Drawing Sheet : R02

Vermont Agency of Transportation  
**RECEIVED**  
CK'D BY JG OK'D BY WL  
March 28, 2014  
RESUBMIT YES Rejected  
BY KH DATE 4-1-2014

| No.  | Description | Date                                    | By       |
|--|-------------|---|----------|
| Project: PITTSFIELD ER BRF 022-1(33)<br>PITTSFIELD, VT   |             |   |          |
| Drawing: DECK CLOSURE POUR   |             |   |          |

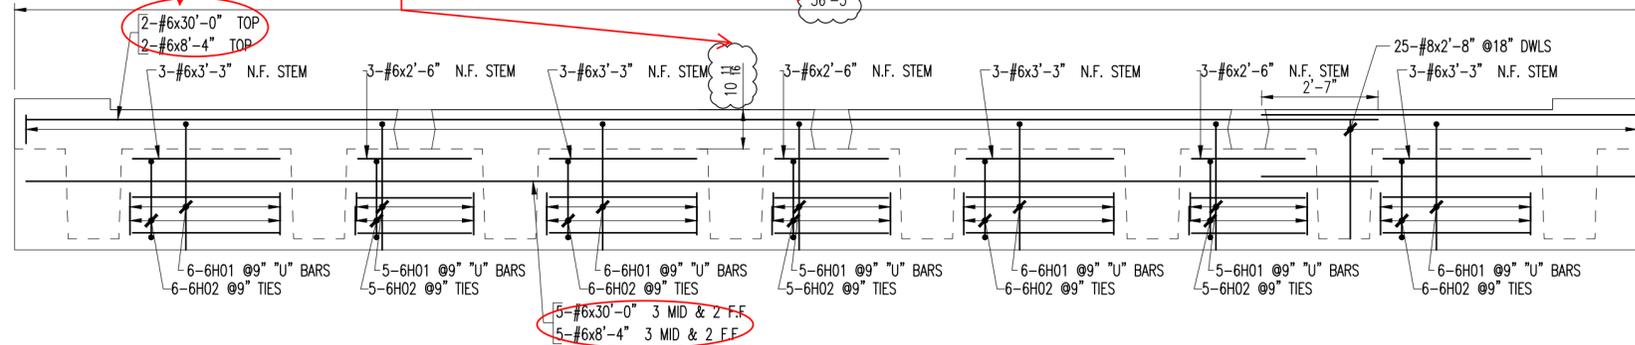
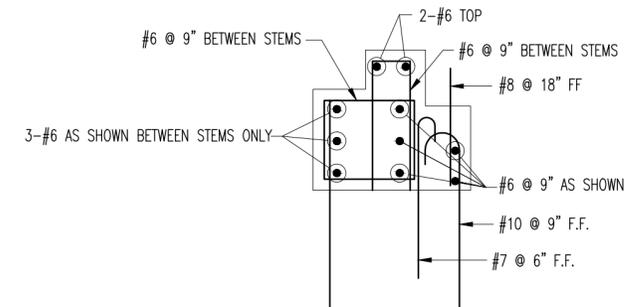
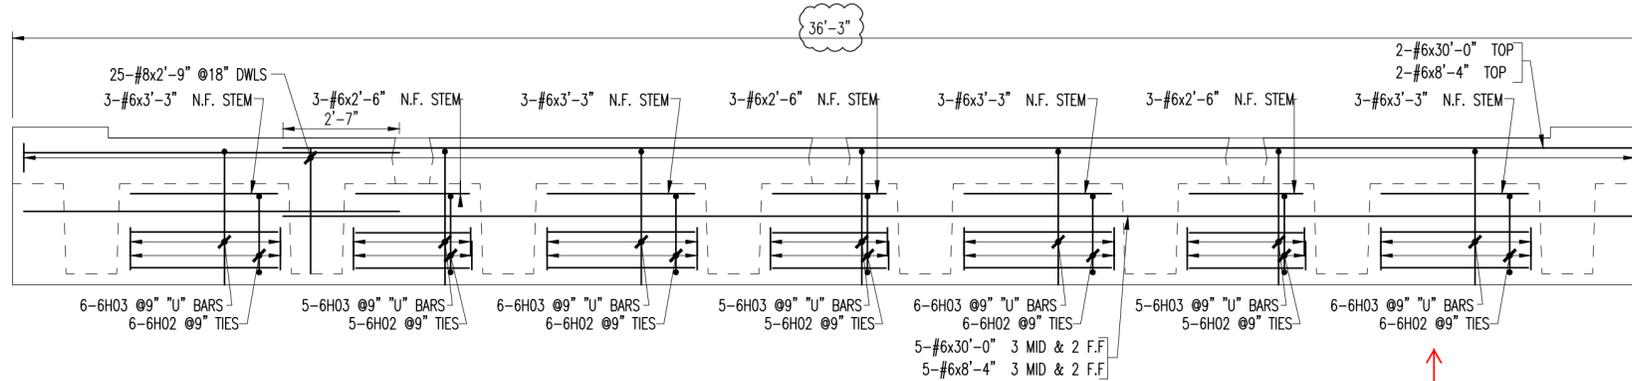
These Bars will need to be extended the full length of the closure pour (TYP).

Flange Thickness is 10 3/4"

The distance to provide the reinforcing is also along the skew (TYP).

The closure pour has been changed to include the cheek walls. Please provide reinforcing between the last stem to the end of each cheek wall. (TYP)

Verify lengths of ALL Horizontal bars as they will be placed along bridge skew. (TYP)

Note: All comments with (TYP) apply to both closure pours.

Note: 3 x 30'-0" Bars provide more length than required. Okay.

These Bars will need to be extended the full length of the closure pour. (TYP)

Increase Height of 6H03 and 6H02 by 1" for Next Beam in the final bay.

Please provide Grade and ASTM SPEC
